AGNICO EAGLE

August 7th, 2020

Re: Agnico Eagle's response to Meadowbank (03MN107) and Whale Tail (16MN056) 2019 Annual Report comments

Figure 1. Pond Operational Guideline for Mammoth Lake

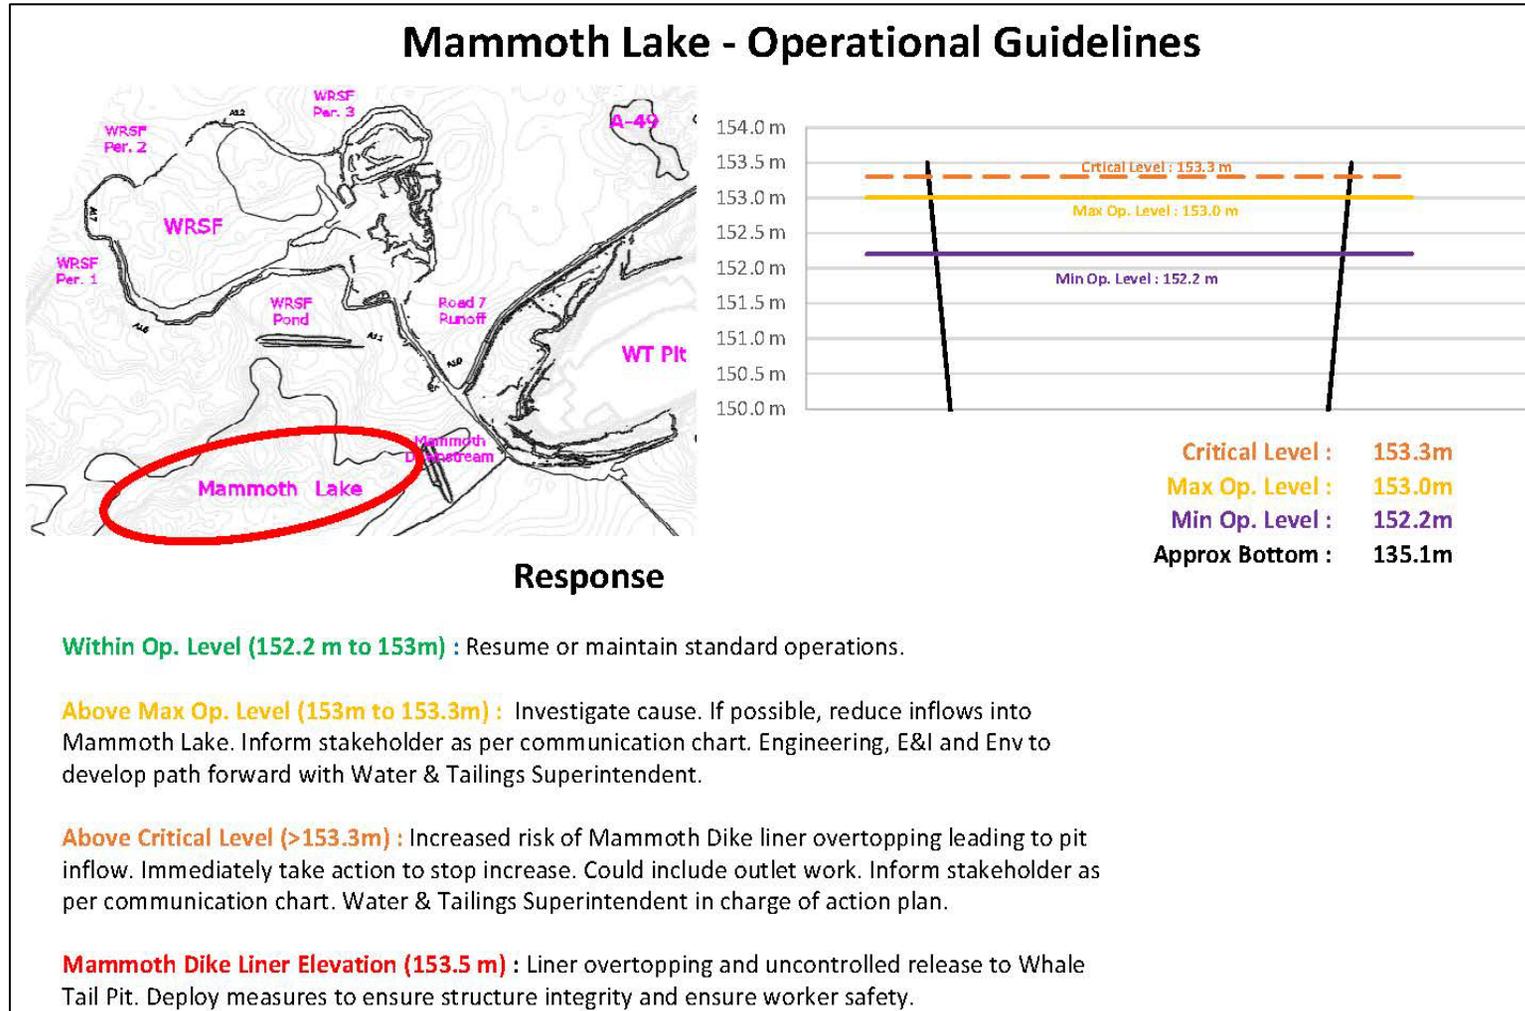
We note that an Adaptive Management Plan has been developed for the Whale Tail site, but does not include adaptive management thresholds and responses based on water levels in the receiving environment.

Recommendation 2: Please adaptive management thresholds, triggers and responses pertaining to water levels in Mammoth Lake, and incorporate these into the Adaptive Management Plan for the Whale Tail site.

Specific thresholds and action levels are intended to provide clarity as to what measures will be taken and when in response to elevated water levels in the receiving environment.

The Adaptive Management Plan for the Whale Tail site is still undergoing the NWB approval process. Pond operational guidelines have been developed for the lakes and ponds at the Whale Tail site to ensure that freeboard is respected during operation. All pond operational guidelines will be included in the next version of the Whale Tail Water Management Infrastructure OMS Manual. Figure 1 is the pond operational guideline for Mammoth Lake.
